**SECTION 4.55(1A) MODIFICATION APPLICATION TO MODIFY SSDA 7140
SAINT IGNATIUS' COLLEGE RIVERVIEW SENIOR SCHOOL CAMPUS
2-60 RIVERVIEW STREET AND TAMBOURINE BAY ROAD, RIVERVIEW**

2-60 Riverview Street and Tambourine Bay Road, Riverview
SSD 7140 - Concept Master Plan and Stage 1 Detailed Built Form

Figure 2. Approved Concept Master Plan (Source: PMDL, 2015)

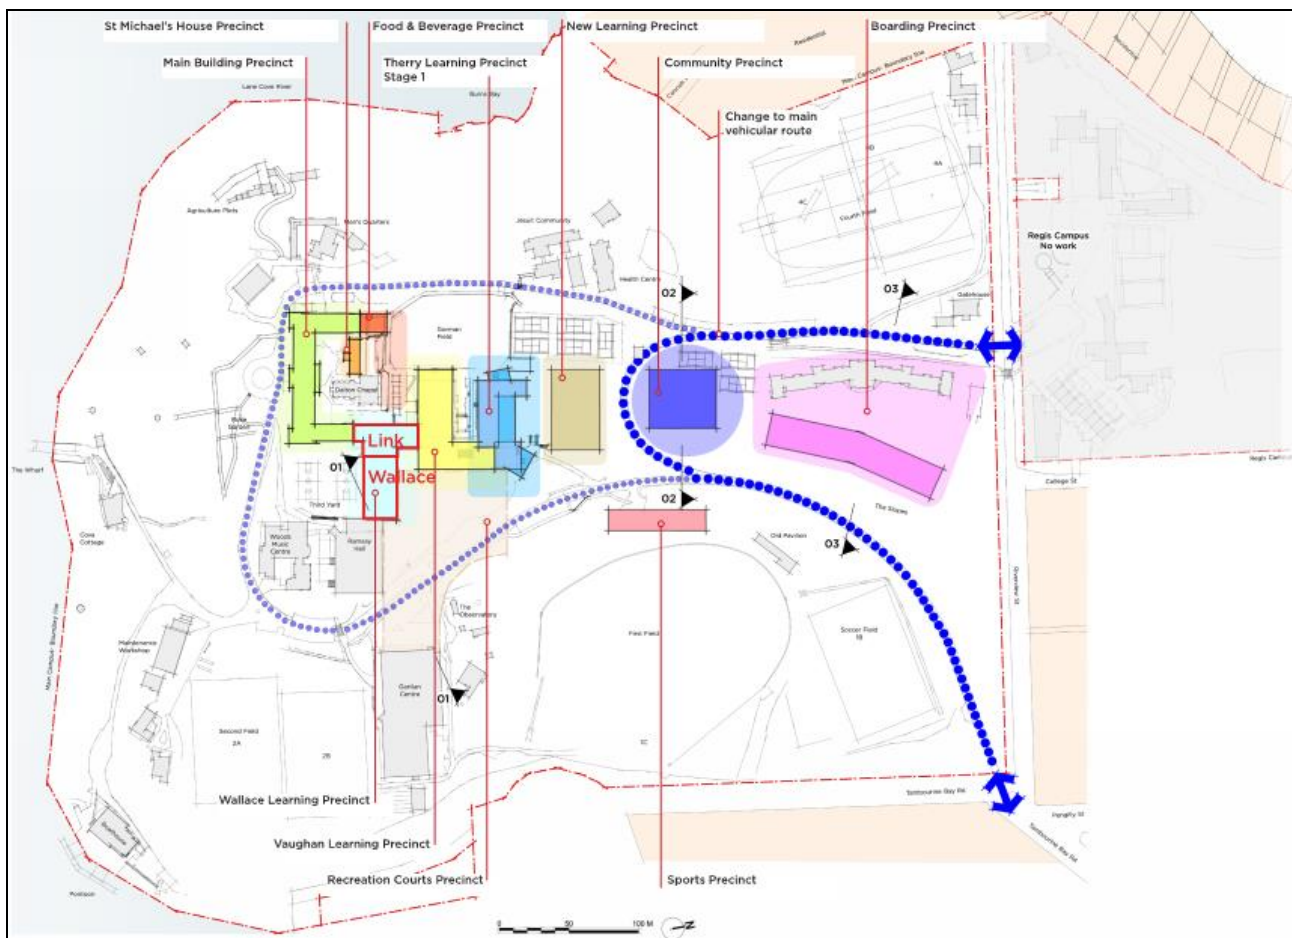
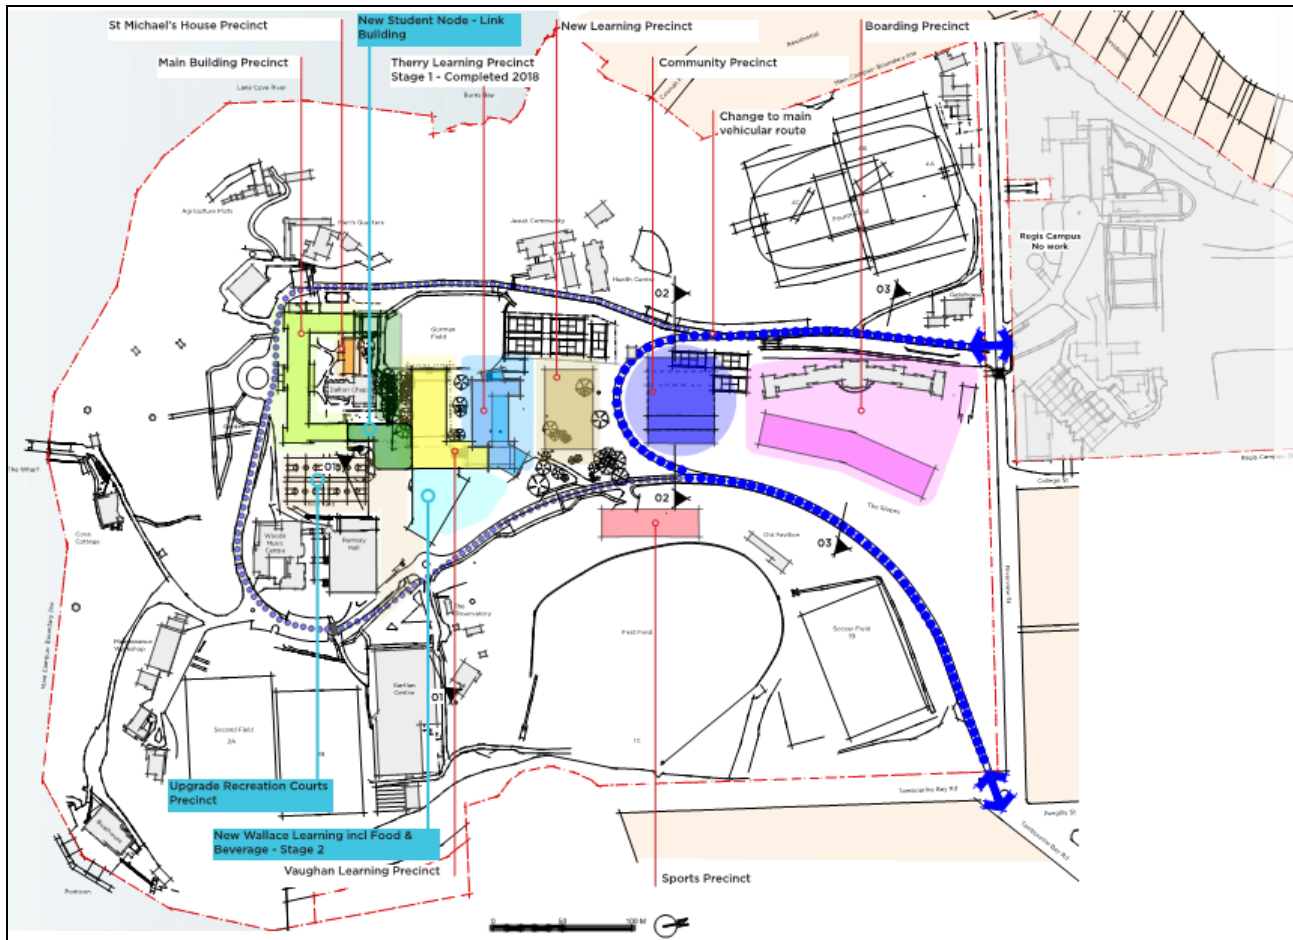
The proposed modification specifically relate to the Wallace Precinct (Stage 2).

Figure 2 below illustrates the previously approved Concept Master Plan. **Figure 3** illustrates the Concept Master Plan, as modified.

Figure 4. Approved Wallace Learning Precinct (Source: PMDL, 2019)

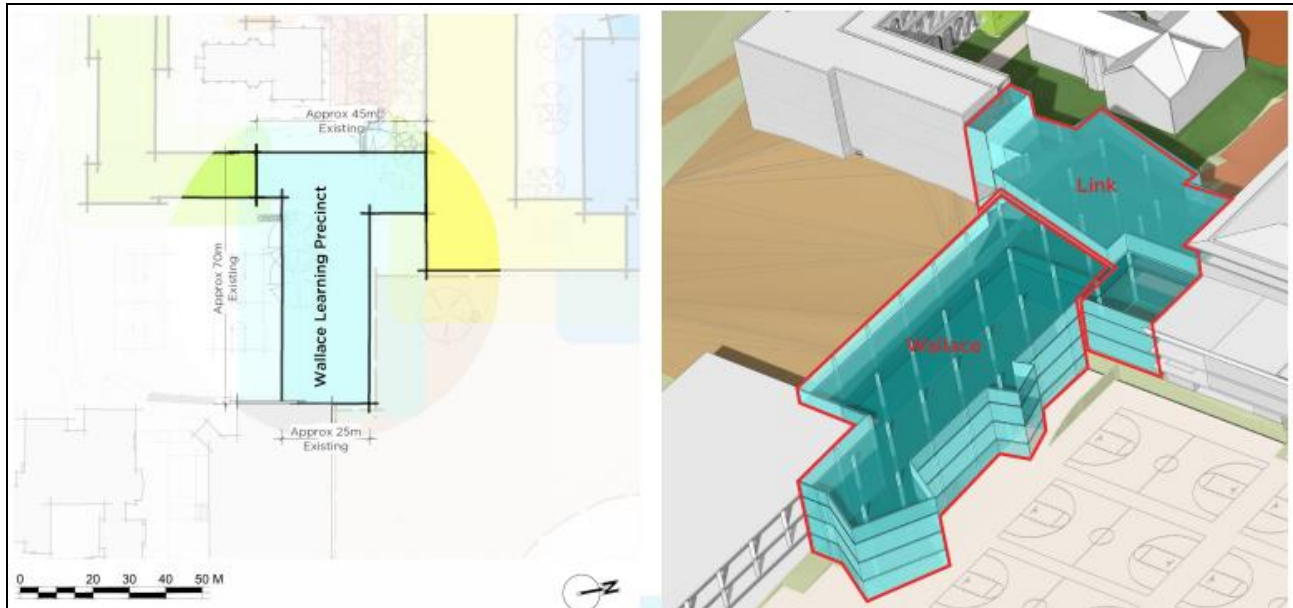
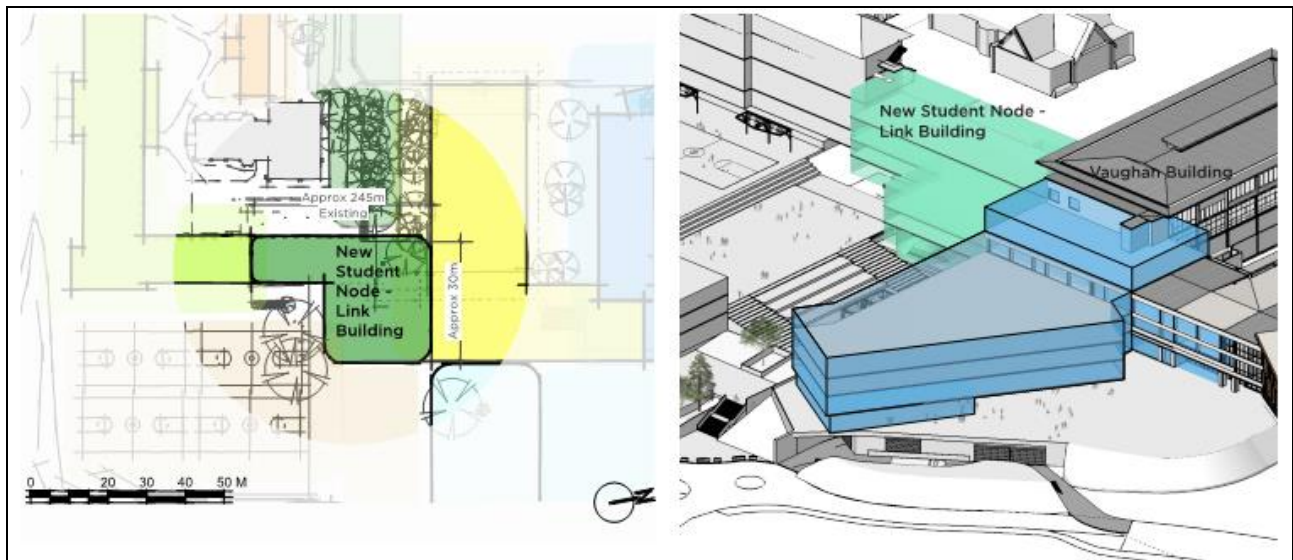
The assessment determined that what was proposed as a new building termed the 'Wallace Learning Precinct' would need to be implemented in two stages to enable the continued operation of the College both during and after completion of any future works. Hence the works have been separated into two (2) smaller separate stages, the first known as the Wallace Building Precinct and the second being the Link Building Precinct. The new Wallace Building will be known as Stage 2.

Stage 2 involves the construction of a new five-storey building with basement and new canteen to the north of the original Wallace Building. The new building will house Science, Technology, Engineering, Mathematics and PDHPE faculties as well as pastoral care house areas. Options utilising the original building as shunt space for construction works and beyond to mitigate the requirement for demountable is being explored. A portion of the O'Neill Learning Precinct will be refurbished to provide a link between the O'Neill Precinct and the new Wallace Building.

The proposed changes have resulted in the relocation of the Wallace Building, with the built form being relocated 30 metres north of the previous building footprint. The location Link Building will remain where it was previously shown.

Additionally, the separation of the Precinct into two (2) stages has subsequently generated additional floor area of **1,090m²** for the new Wallace Learning Building, to meet the operational requirements of the College.

Figure 4, Figure 5 and Figure 6 below illustrate the previously approved and proposed modification respectively.
